Access Compliance Report

Public Rights-of-Way

Intersection ID: 43869	Main Street: CALDWELL_RIDGE_PY	Cross Street: SIDNEY_CREST_AV	Location: SW
ADA ID: 7C07BA7DC791	Ramp Type: Perp	Initial Pass/Fail: Fail	Overall Compliance: No
Severity Score: 21.25			
Codes/Mitigation Info/Possible Solution		Field Measurements/Component Compliance

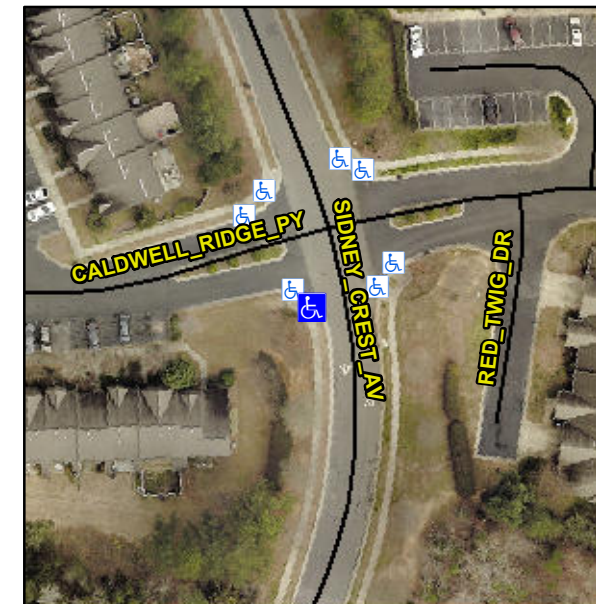
Not Found, R304.5.1, R304.5.3

Compliance	Description	Data	Compliance	Description	Data
N/A	Ramp Length (in)	48.5	Yes	Ramp Slope (%)	5.7
No	Ramp Width (in)	40.5	No	Ramp XSlope (%)	5.1
N/A	Flare Type LT	N/A	N/A	Flare Type RT	N/A
N/A	Flare Slope LT (%)	N/A	N/A	Flare Slope RT (%)	N/A
N/A	Flare Traversable LT?	N/A	N/A	Flare Traversable RT?	N/A
N/A	Landing Length (in)	N/A	N/A	DWS Provided?	N/A
N/A	Landing Width (in)	N/A	N/A	DWS Contrast?	N/A
N/A	Landing Slope (%)	N/A	N/A	DWS Length (in)	N/A
N/A	Landing X Slope (%)	N/A	N/A	DWS Full Width?	N/A
N/A	Landing Curb? (Y/N)	N/A	N/A	DWS Offset (in)	N/A
N/A	Shared Landing?	N/A			
N/A	Gutter Ponding?	N/A	N/A	Gutter Slope (%)	N/A
N/A	Gutter Lip Ht (in)	N/A	N/A	Gutter X Slope (%)	N/A
N/A	Painted X Walk1?	No	N/A	Painted X Walk2?	N/A
	X Walk 1 Direction	To E		X Walk 2 Direction	N/A
N/A	X Walk 1 Width (in)	N/A	N/A	X Walk 2 Width (in)	N/A
	X Walk 1 Slope (%)	1.0		X Walk 2 Slope (%)	N/A
	X Walk 1 X Slope (%)	2.1		X Walk 2 X Slope (%)	N/A

Remove & Replace Entire Ramp.
